CASE NO. FP-2021-0051
ORDER OF CONDITIONAL
APPROVAL OF FINAL PLAT

ORDER OF CONDITIONAL APPROVAL OF FINAL PLAT
FOR GANDER CREEK NORTH SUBDIVISION NO. 2 FP-2021-0051

STAFF REPORT COMMUNITY DEVELOPMENT DEPARTMENT

SUBJECT: FP-2021-0051
Gander Creek North Subdivision No. 2

PLAT SHOWING
GANDER CREEK NORTH SUBDIVISION NO. 2
 LOCATED IN THE NE 1/4 OF THE NE 1/4
 OF SECTION 32, T.4N., R.1W., BOISE
 MERIDIAN, CITY OF MERIDIAN, ADA COUNTY, IDAHO
 2021

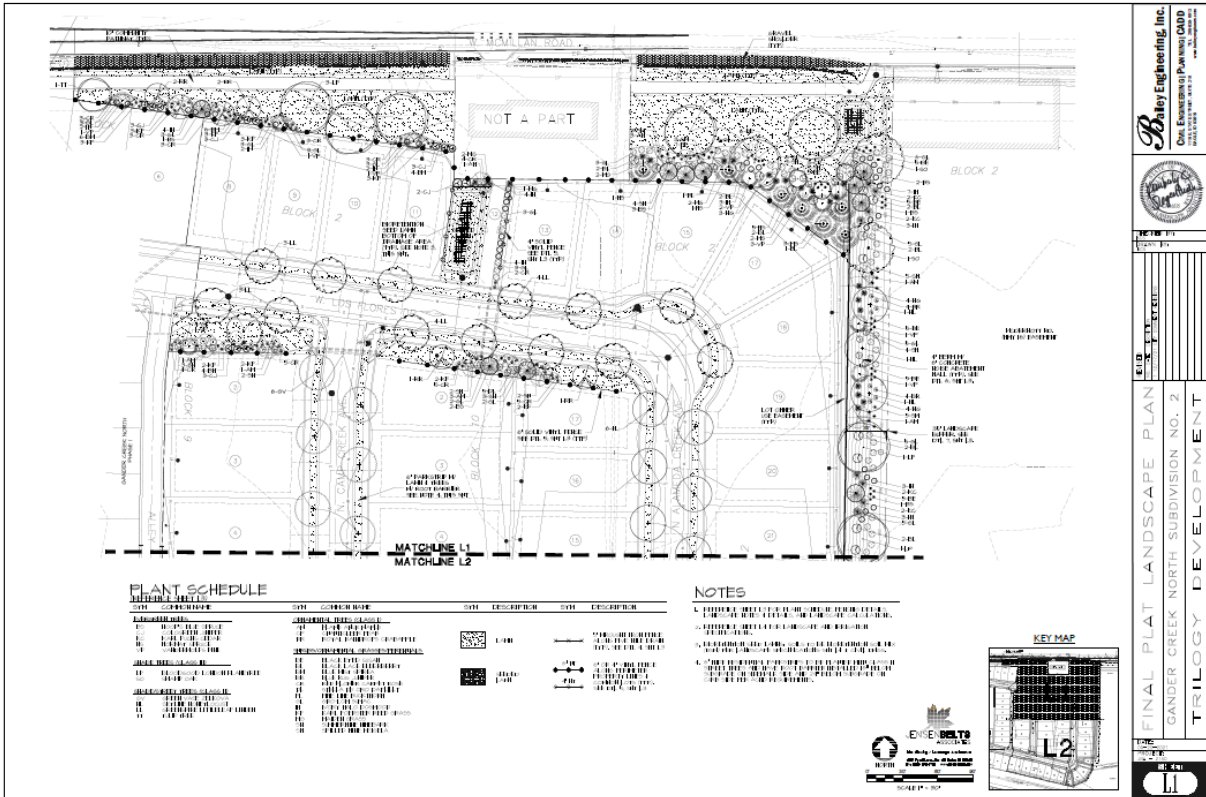
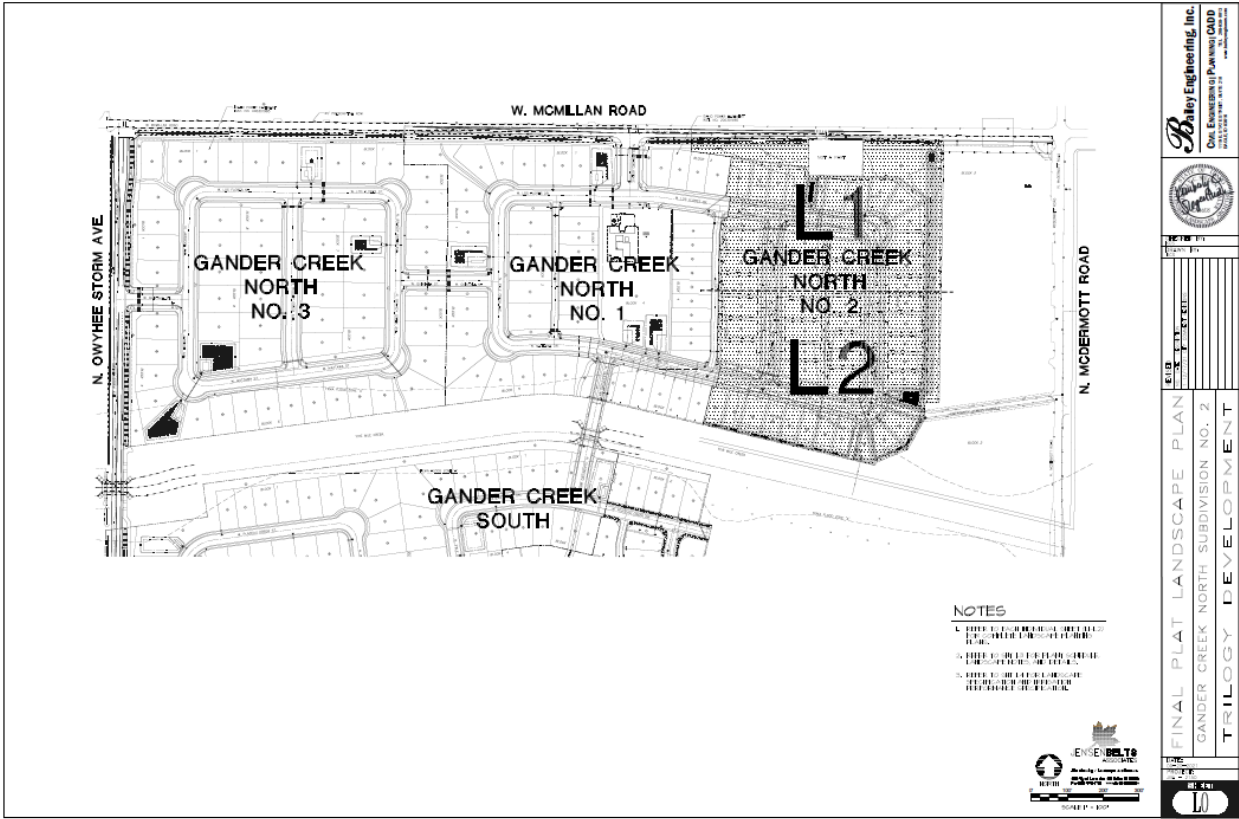
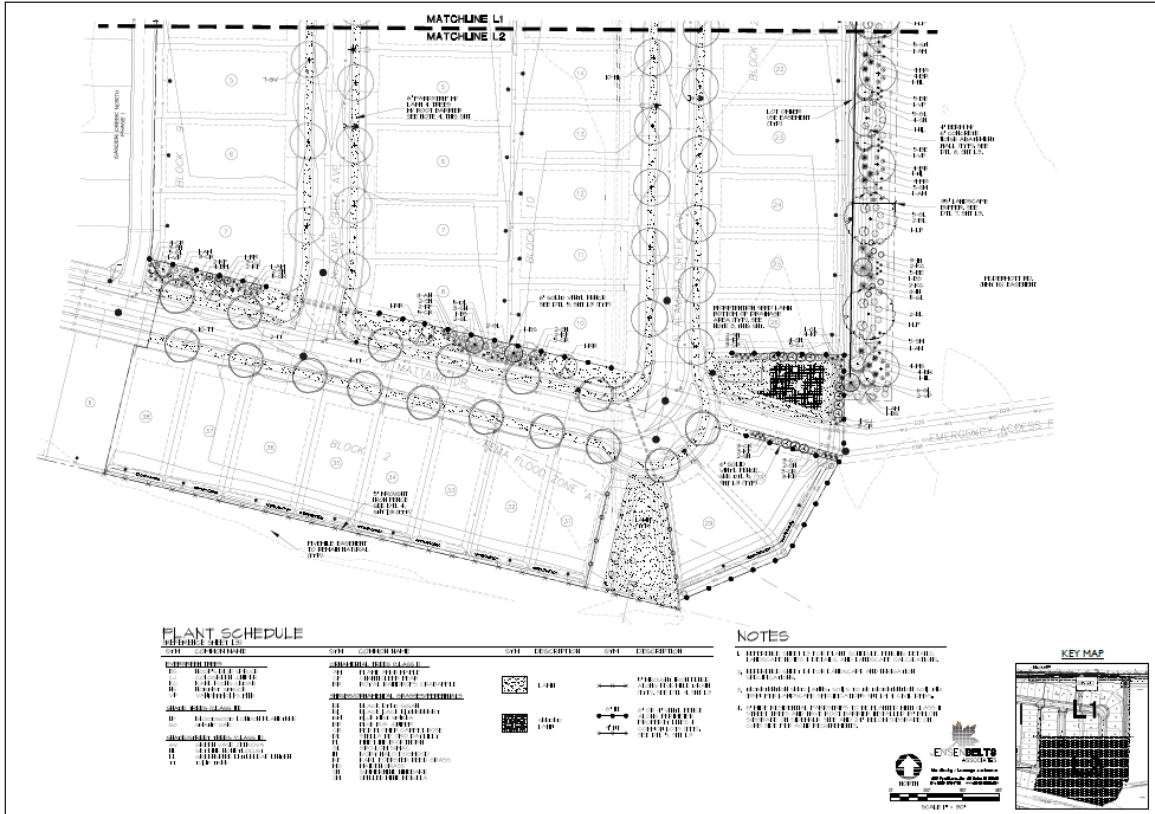
- a. Note #2: Include Lot 12, Block 2 as also containing the ACHD storm water drainage system.
 - b. Note #10: Include the recorded Instrument Number for the ACHD Permanent Easement.

- c. Note #11: Include the recorded Instrument Number of the ACHD License Agreement.
 - d. Note #12: Include the recorded Instrument Number of the City of Meridian Water & Sewer Easement.

- e. Note #13: Include the recorded Instrument Number of the Meridian pathway easement.
 - f. Note #14: Include the recorded Instrument Number for the ACHD Permanent Easement. *Is this a duplicate note (see Note #10)?*

- g. Berm detail on Sheet 3.4 of the construction drawings: Increase the height of the berm to 6-feet per requirement of the development agreement.
 - h. Depict local street access as set forth in UDC 11-3A-3 or a common driveway meeting the standards listed in UDC 11-6C-3D to the out-parcel (Parcel #S0432110050) on W. McMillan Rd. per condition #VIII.A.2k of the preliminary plat.

- i. The use easement described in Note #15 and graphically depicted on the plat is supposed to go to the top of the berm to the wall; it appears to stop short of that location – revise accordingly.

FINAL PLAT LANDSCAPE PLAN
GANDER CREEK NORTH SUBDIVISION NO. 2
TRILOGY DEVELOPMENT

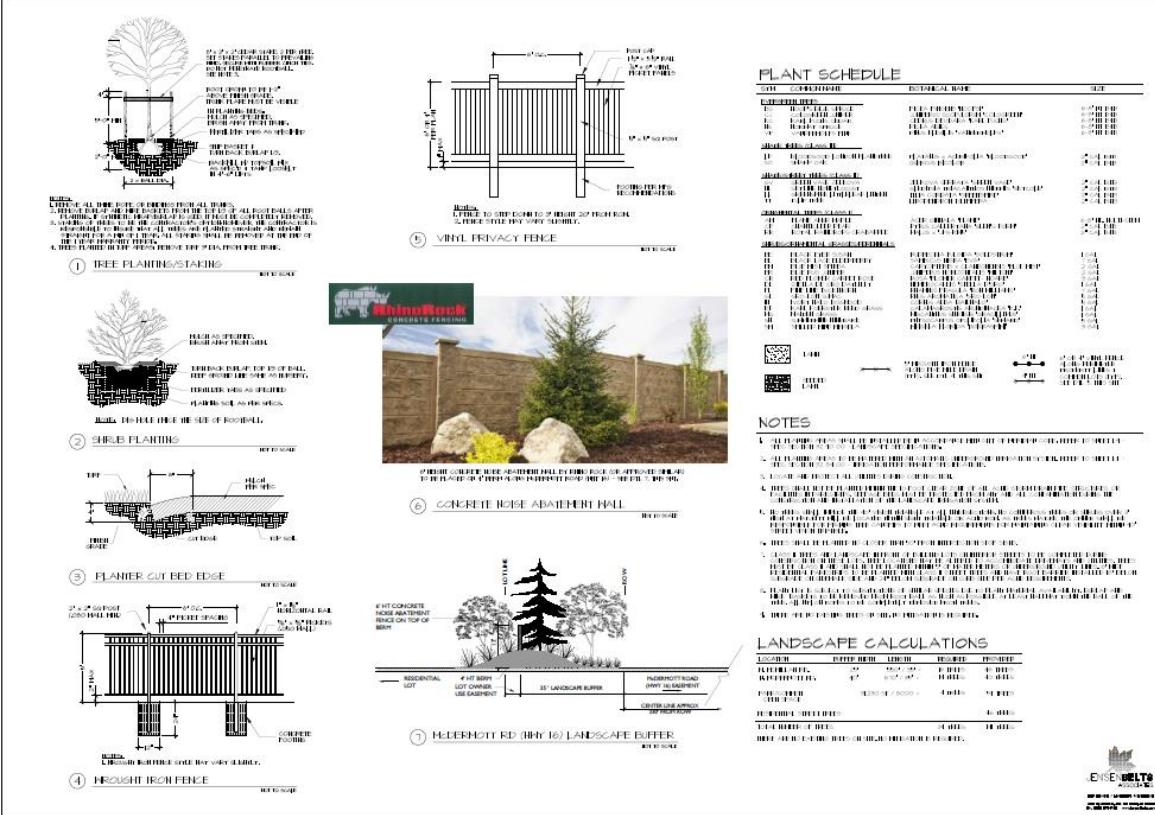
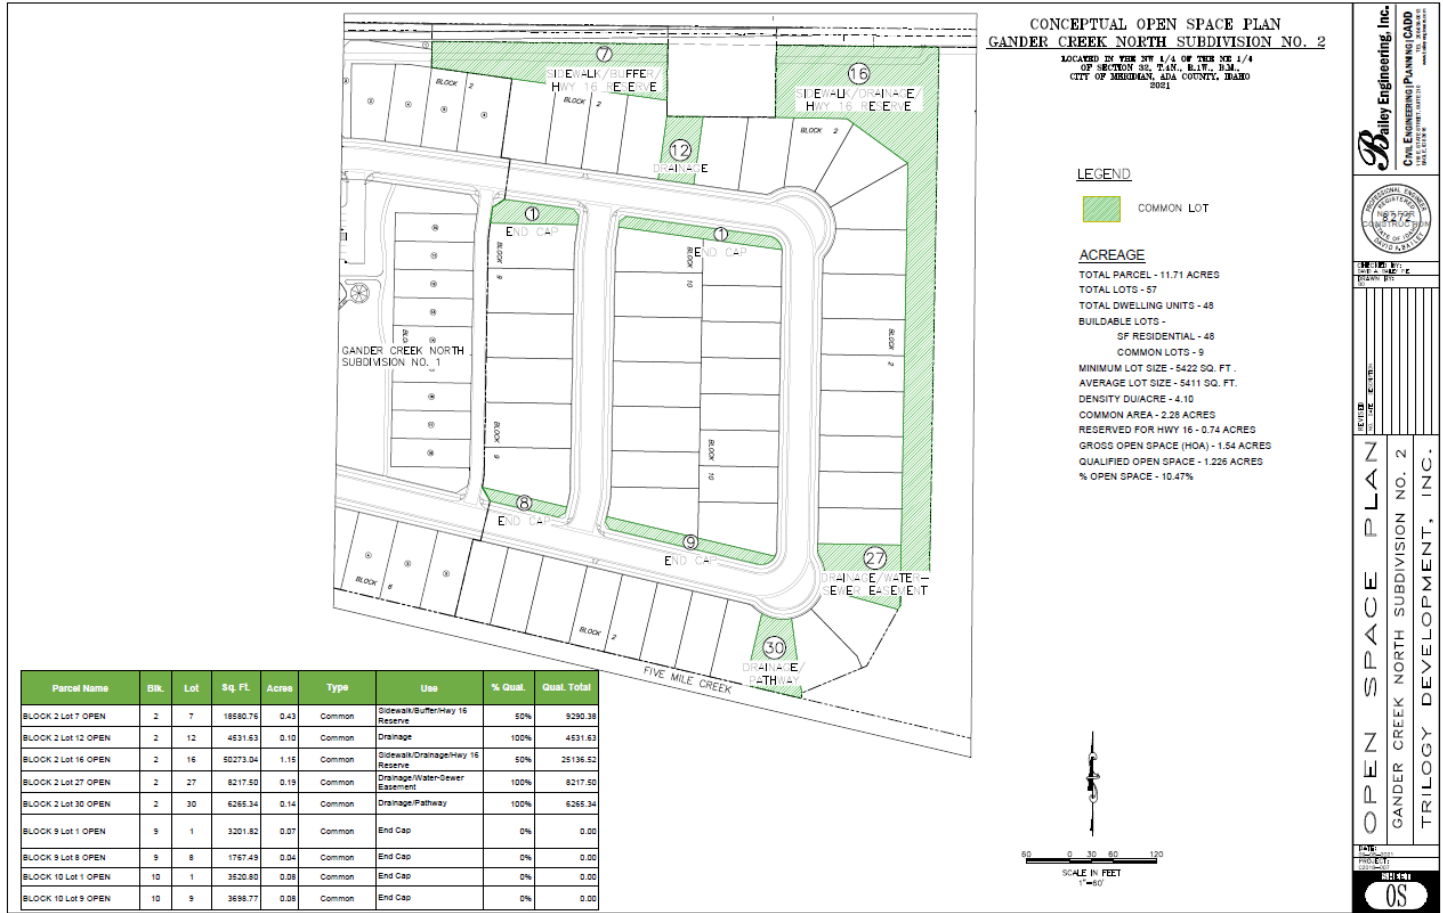
5. The landscape plan prepared by Jensen Belts Associates, dated 09/20/2021, included in Section V.C, shall be revised as follows:
 - a. A minimum 35-foot wide street buffer is required along future SH-16 measured from edge of right-of-way to the wall/fence (typically fences are required to be placed on the interior edge of the street buffer per UDC [11-3B-7C.2c](#) but in this case the wall needs to be installed at the top of the berm in order to comply with the noise abatement standards in UDC 11-3H-4D). *If the common lot needs to be widened to accommodate this requirement, the plat shall be amended accordingly. Depict the edge of right-of-way on the plan.*

- b. Increase the height of the berm along the east boundary of the site from 4-feet to 6-feet tall with a 6-foot tall wall on top of the berm as proposed per requirement of the development agreement.

- c. Depict local street access as set forth in UDC 11-3A-3 or a common driveway that complies with the standards listed in UDC 11-6C-3D to the out-parcel (Parcel #S0432110050) on W. McMillan Rd. per condition #VIII.A.2k of the preliminary plat.

- d. Include a detail that depicts the centerline (or estimated centerline) of future SH-16 in relation to the top of the berm/wall verifying it's a minimum of 12 feet higher than the elevation at the centerline of the state highway as required by UDC 11-3H-4D.2, per preliminary plat condition VIII.A.3b. *The Director may approve alternative compliance as set forth in UDC 11-5B-5 where the Applicant has a substitute noise abatement proposal in accord with ITD standards and prepared by a qualified sound engineer as set forth in UDC 11-3H-4D.4.*

- e. Depict a use easement across the back side of the berm on Lot 16, Block 2 adjacent to future SH-16 benefitting adjacent building lots with allowance for side yard fences to be constructed to the wall on top of the berm per preliminary plat condition #VIII.A.3f. *The use easement depicted on the plan doesn't appear to go to the top of the berm.*

- f. Depict off-site landscaping on NMID's property at the southeast corner of the site as depicted on the landscape plan submitted with the preliminary plat if allowed by NMID through a license agreement.
